**ADDENDUM NO. 02**

**DATE: 08/04/2023**

Clark/Mercedes Edwards Theater Remodel Phase 2  
Clovis, CA 93612  
Client Bid No: 2960

DARDEN PROJECT NO. 2215  
DSA File Nos. 10-27  
DSA APPL. NO. 02-121097

J4	1 Hour Rated Wall Assembly
3" = 1'-0"

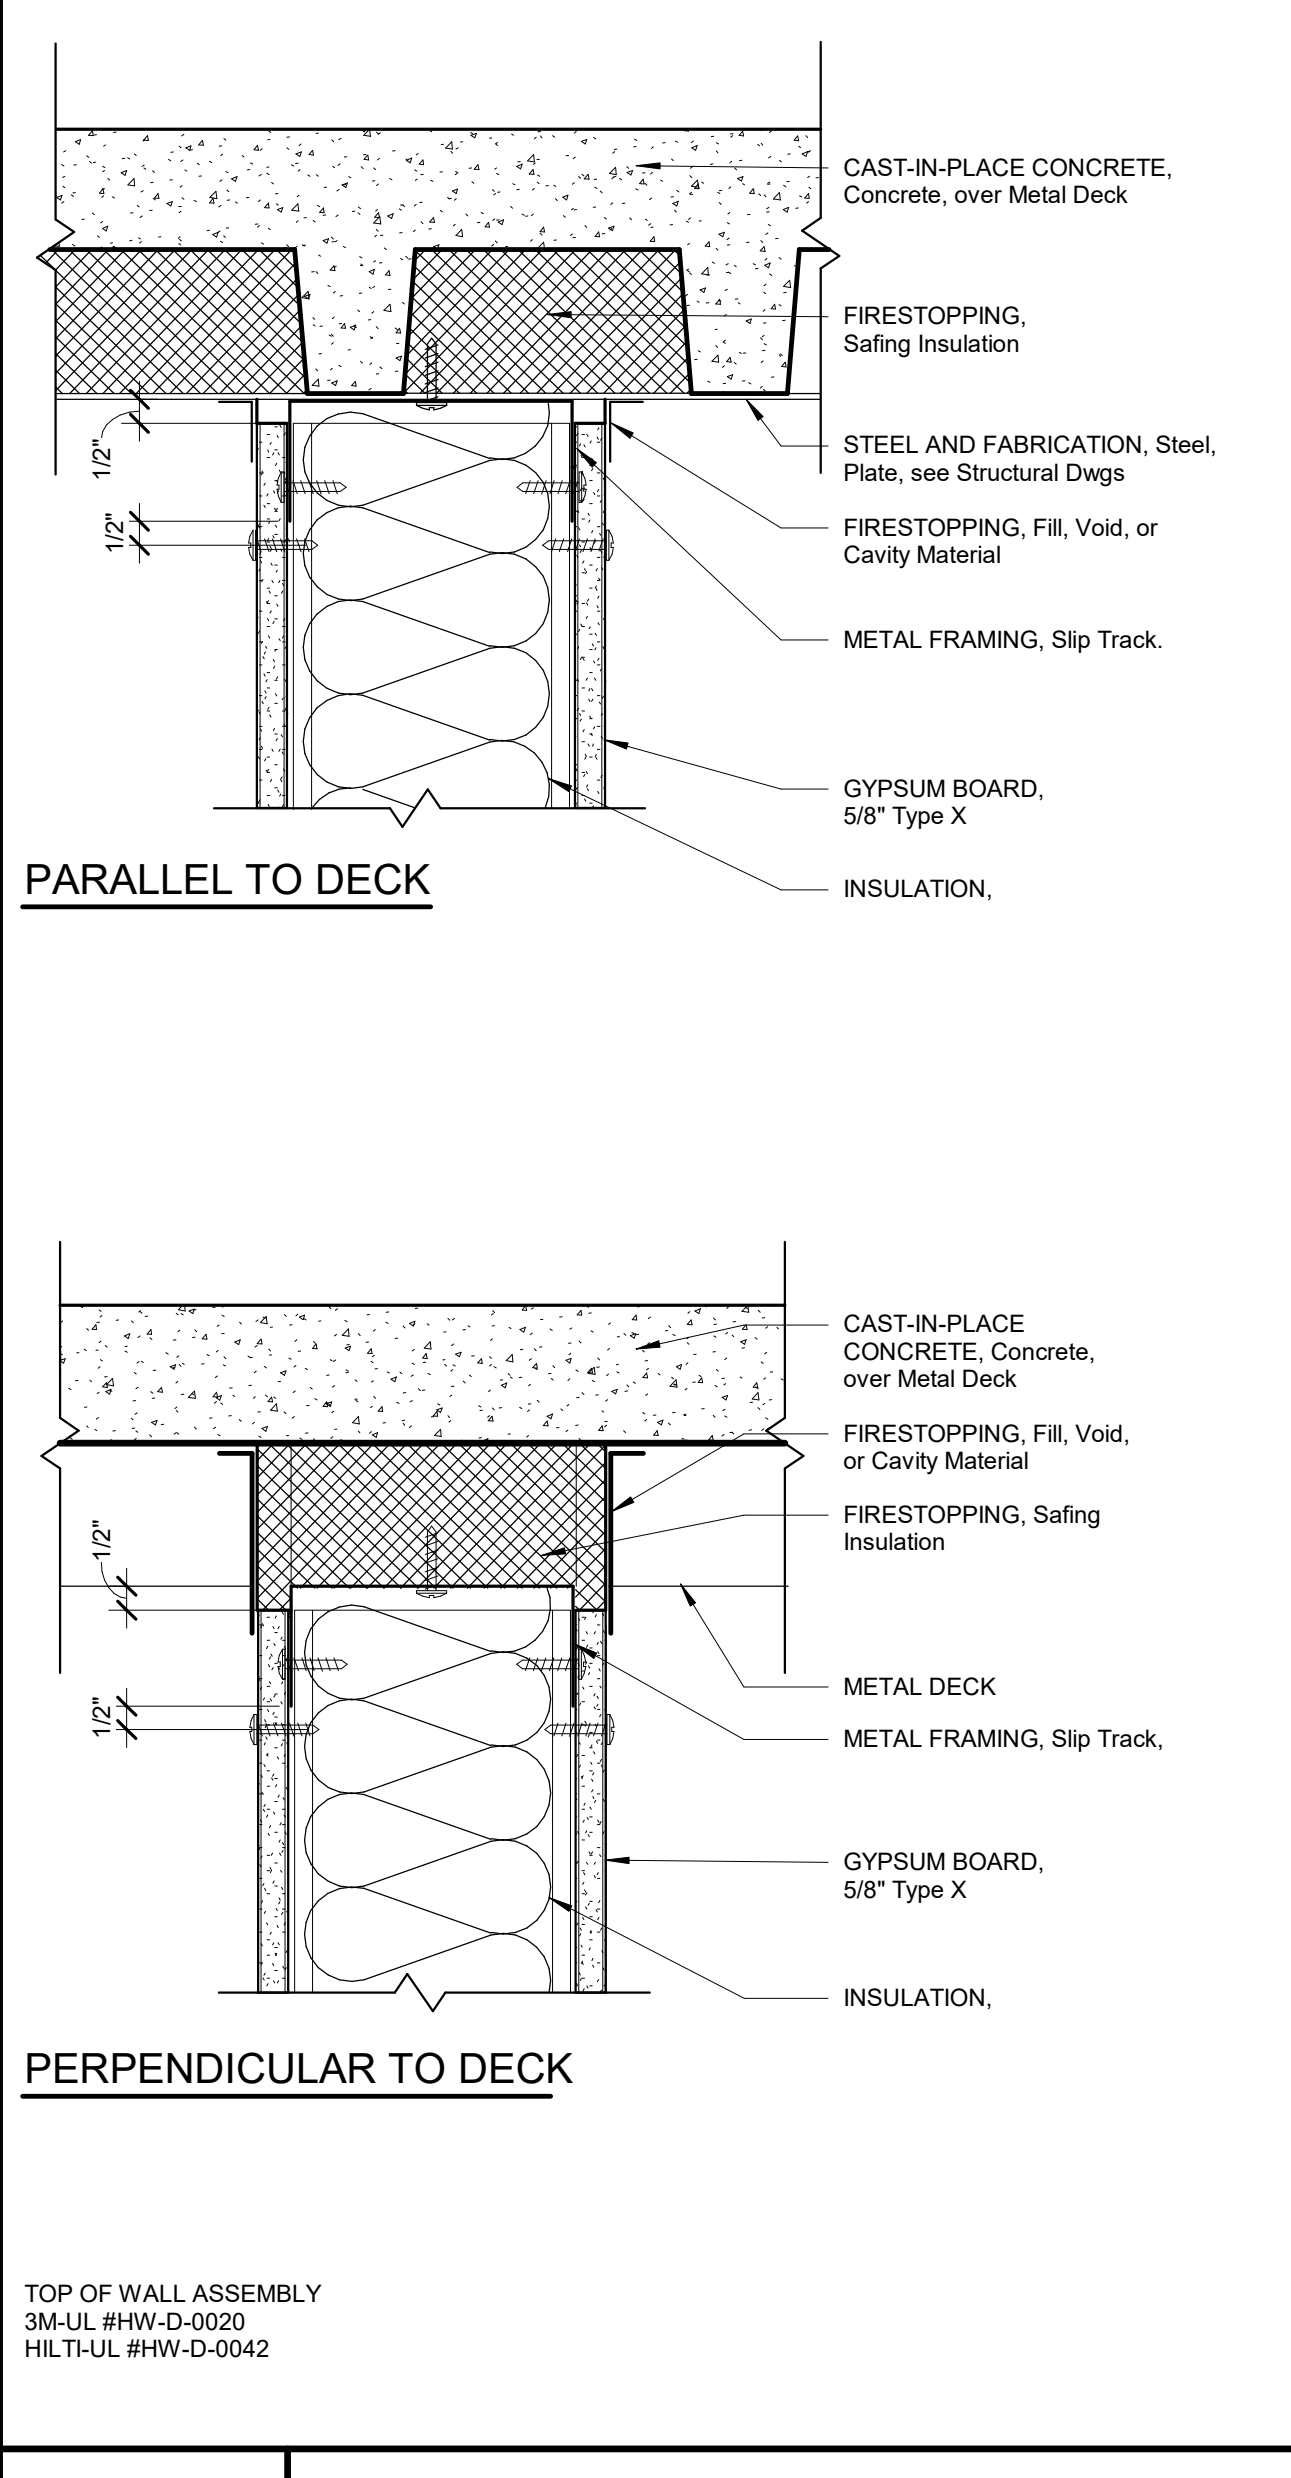
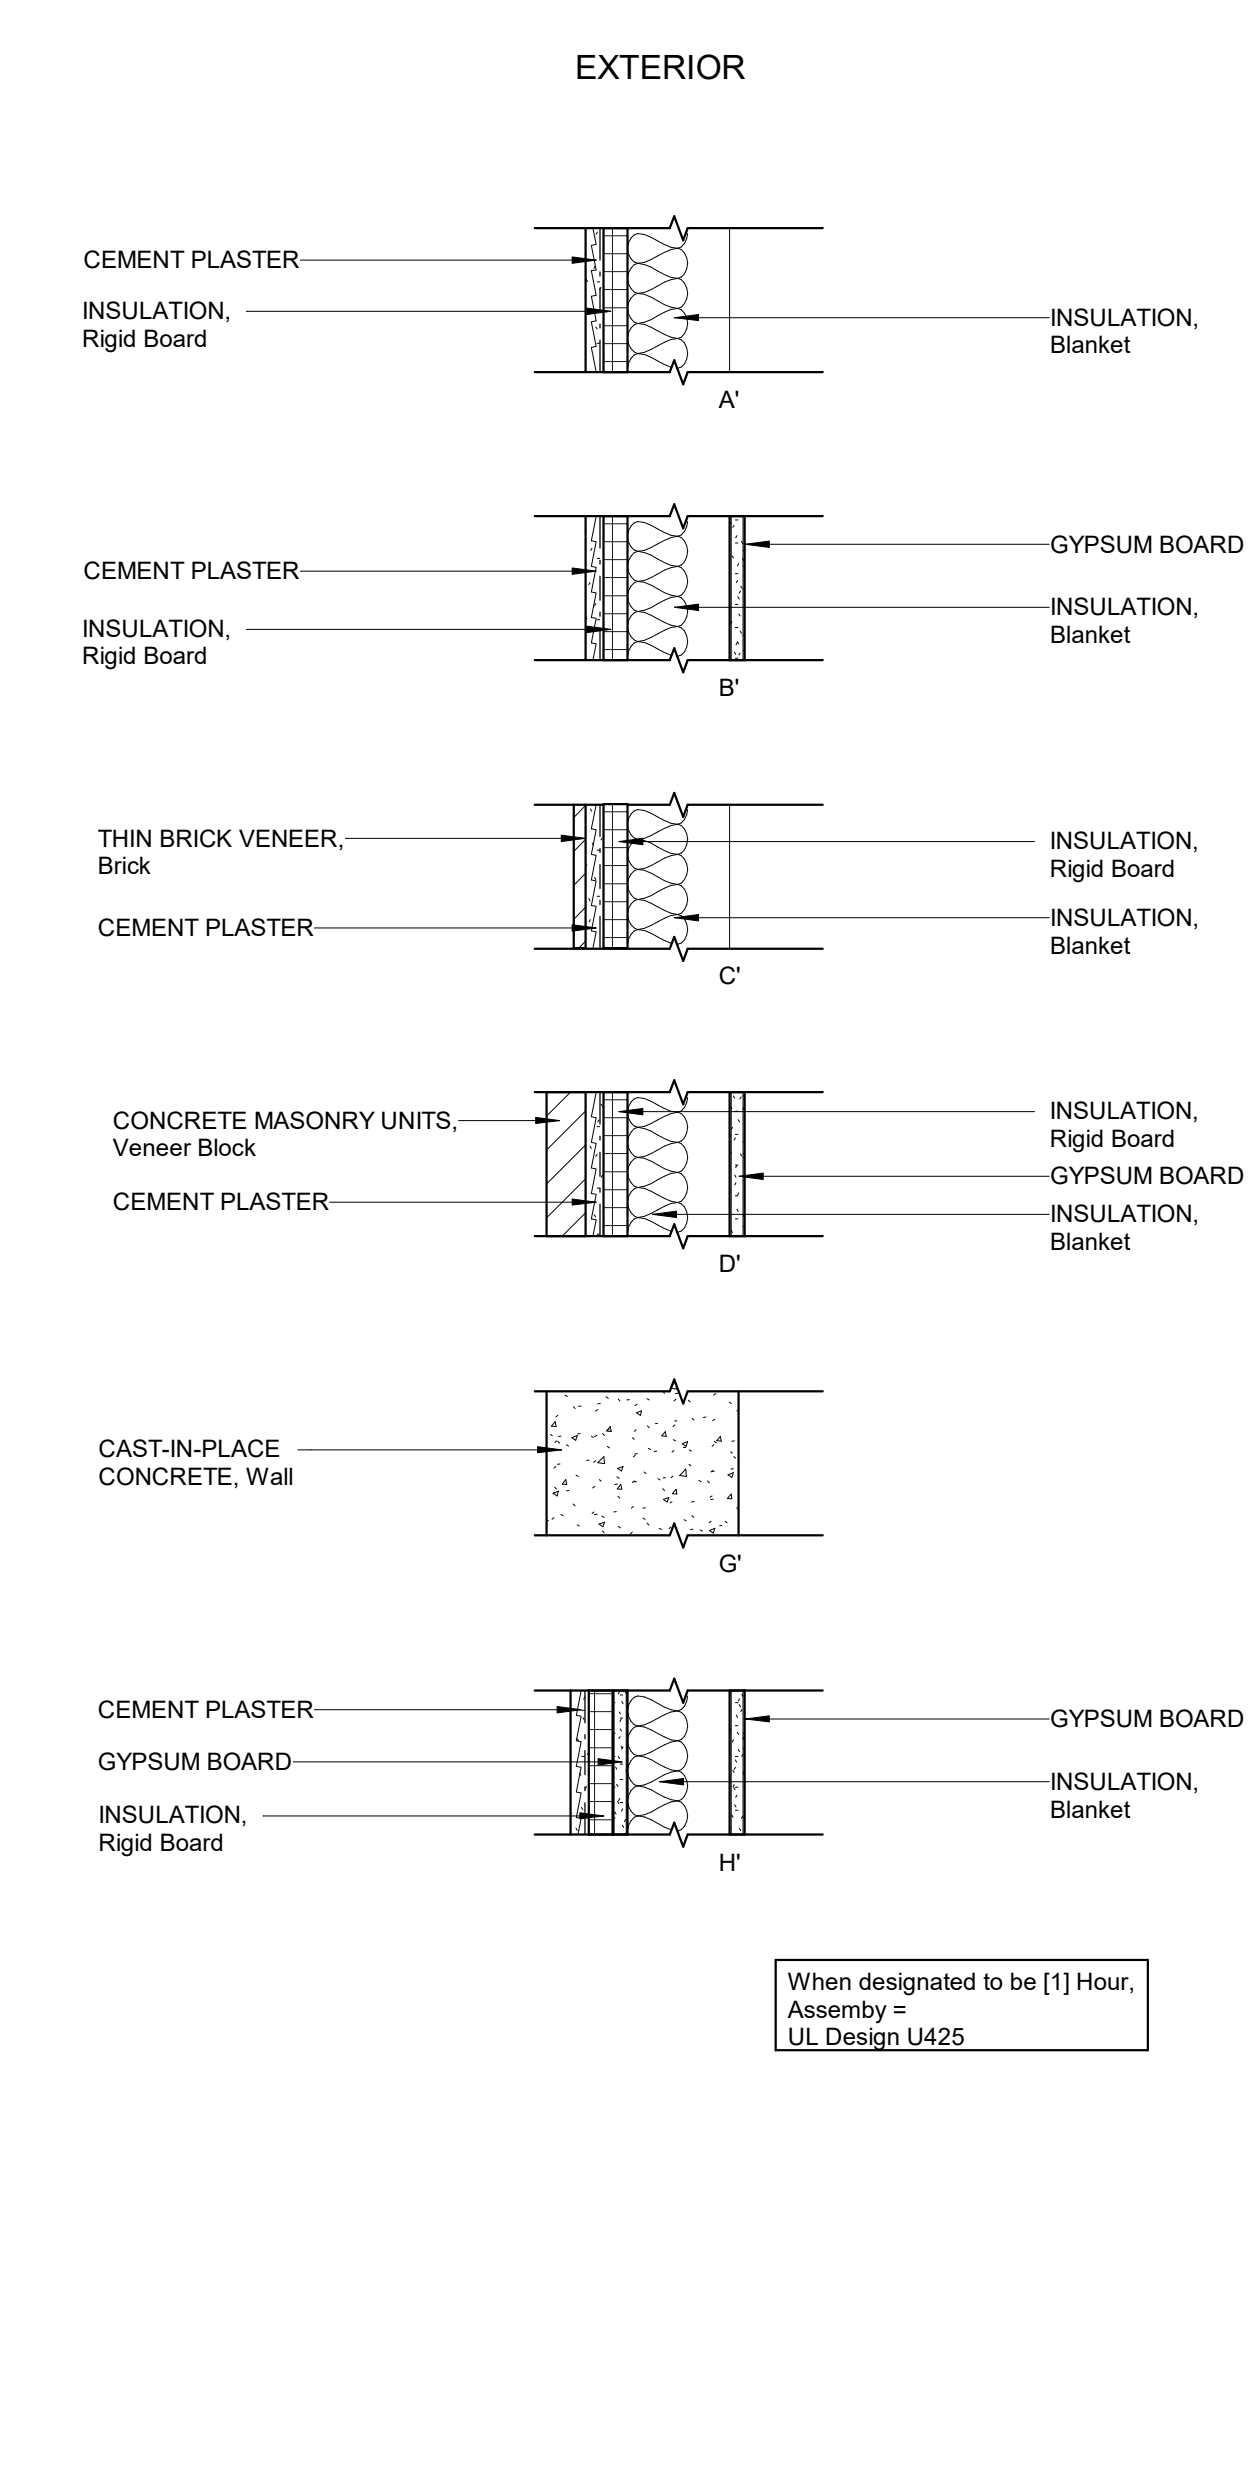
1. Added detail J4. See attached sheet AD02-AX03.
